Agenda - Executive Policy Committee - June 16, 2004

Report - Standing Policy Committee on Property and Development - June 8, 2004

Item No. 28 Amendment to Development Agreement AG 42/87 - Canterbury Park Phase 2
File DASZ 42/87

Re: Canterbury Park Phase 2 – DASZ 42/87

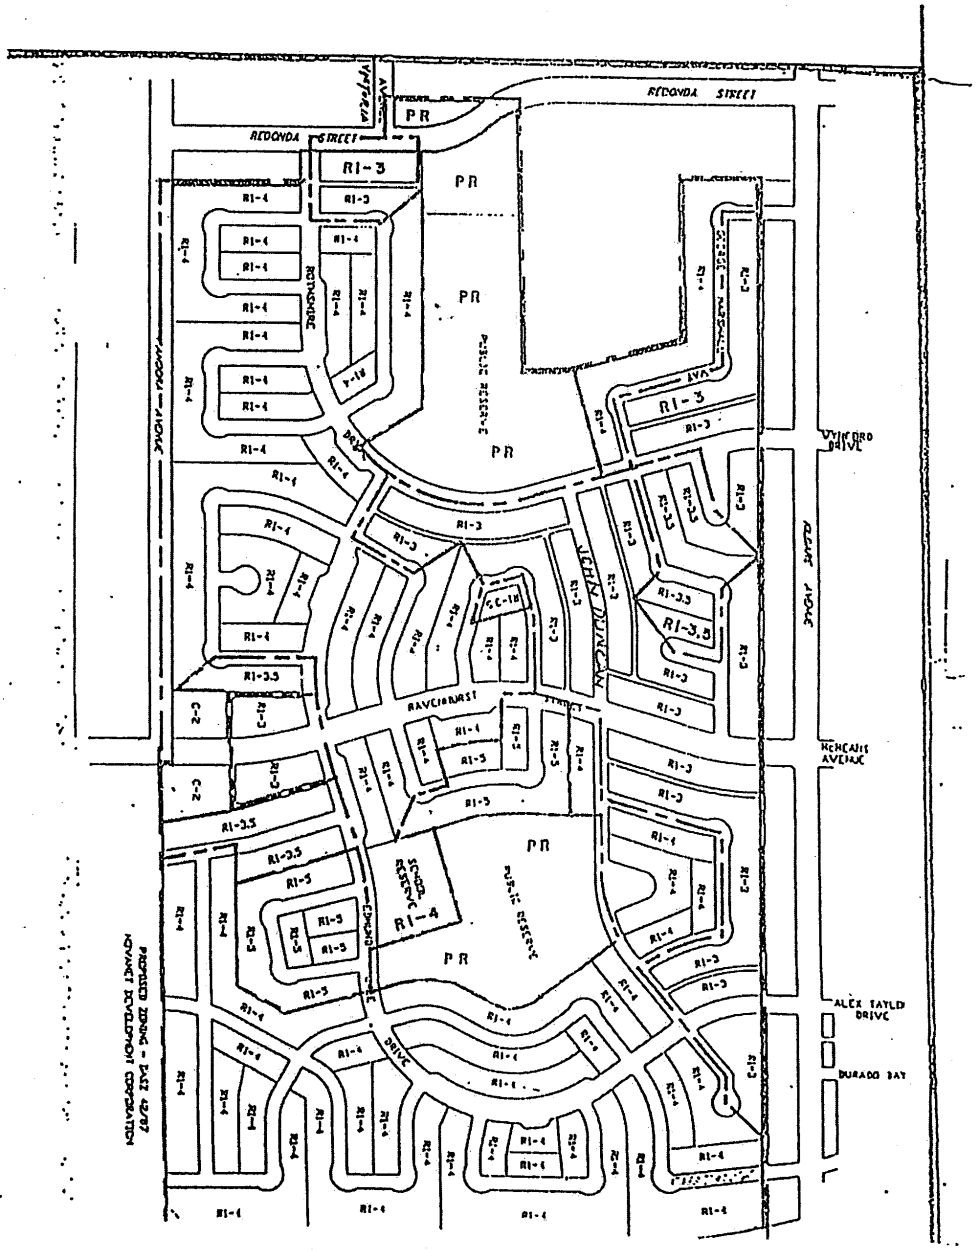
1. That the phasing plan approved by Council on August 2, 1989, be amended to allow Phase 2a. to be registered and developed as shown on Map 3.

On August 9, 1995, Council enacted By-law 6680/95 which authorizes the registration of a plan of subdivision within Phase 2 of the plan of subdivision and related phasing plan approved by Council on May 31, 1989 and August 2, 1989, respectively. On April 1, 2004, the Developer advised the Planning, Property and Development Department that it would like to proceed with the registration and development of a portion of Phase 2 as shown on the plan attached hereto and identified as Map 3. The Developer's proposal was reviewed by the administration and found reasonable from a servicing and vehicular access perspective.

1. The phasing plan approved by Council on August 2, 1989 be amended to allow Phase 2a) to be registered and developed as shown on Map 3, and
2. Development Agreement AG 42/87 be amended as required to allow the servicing of Phase 2a) and the prorating of the development costs associated with Phase 2.

Map 1 to Report dated April 26, 2004 for AG 42/87

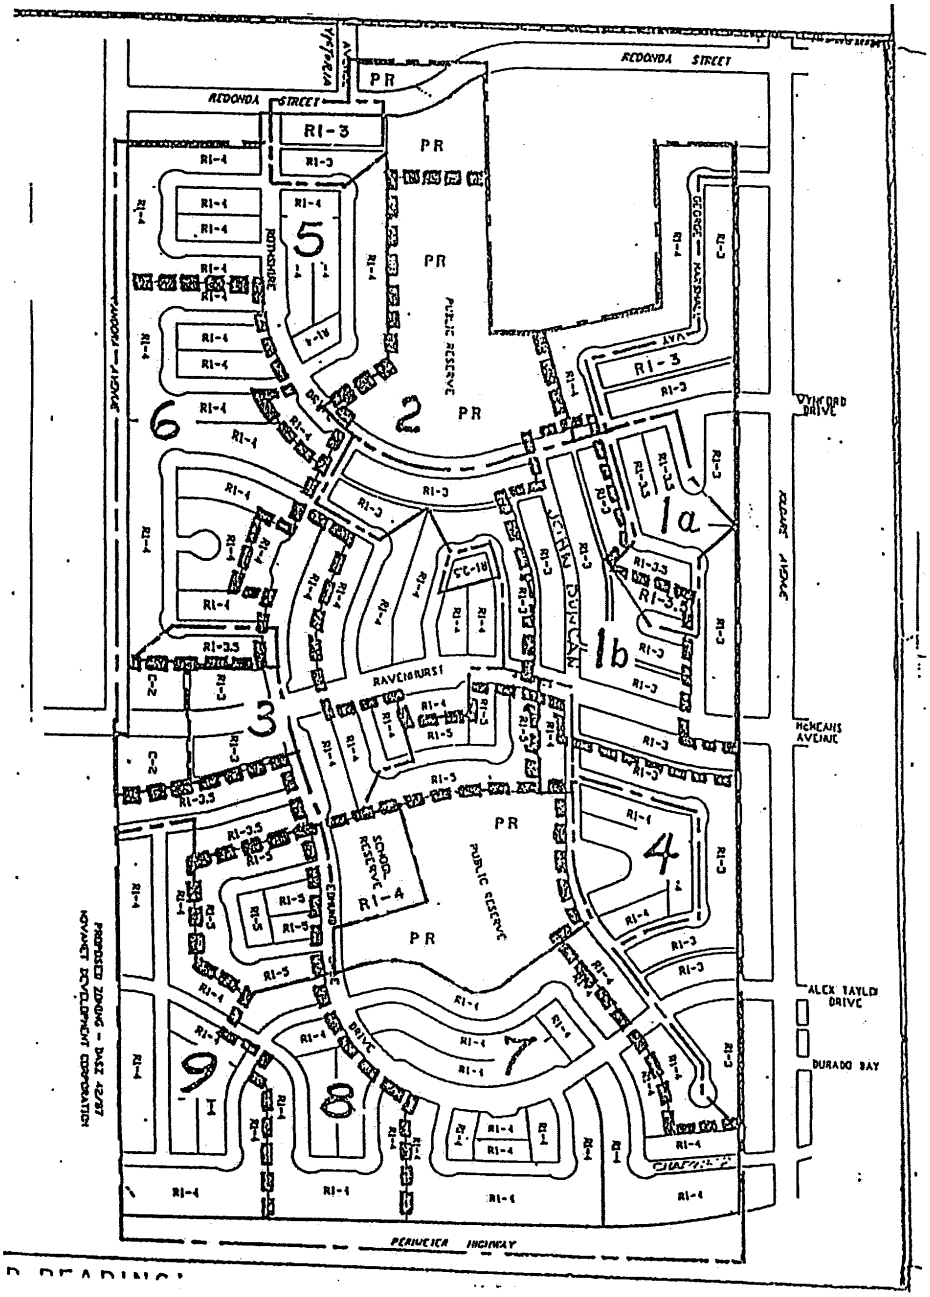
Council at its meeting held on May 31, 1989 approved DASZ 42/87 being an application by Novamet Development Corporation to subdivide and rezone approximately 240 acres of land located south of Kildare Avenue and east of Redonda Street. A copy of the approved plan is attached hereto and identified as Map 1. At the Developer's request, Council at its meeting held on August 2, 1989, approved the registration of the approved plan of subdivision in phases in accordance with the plan attached hereto and identified as Map 2. To date the following portions of the approved plan of subdivision have been registered:
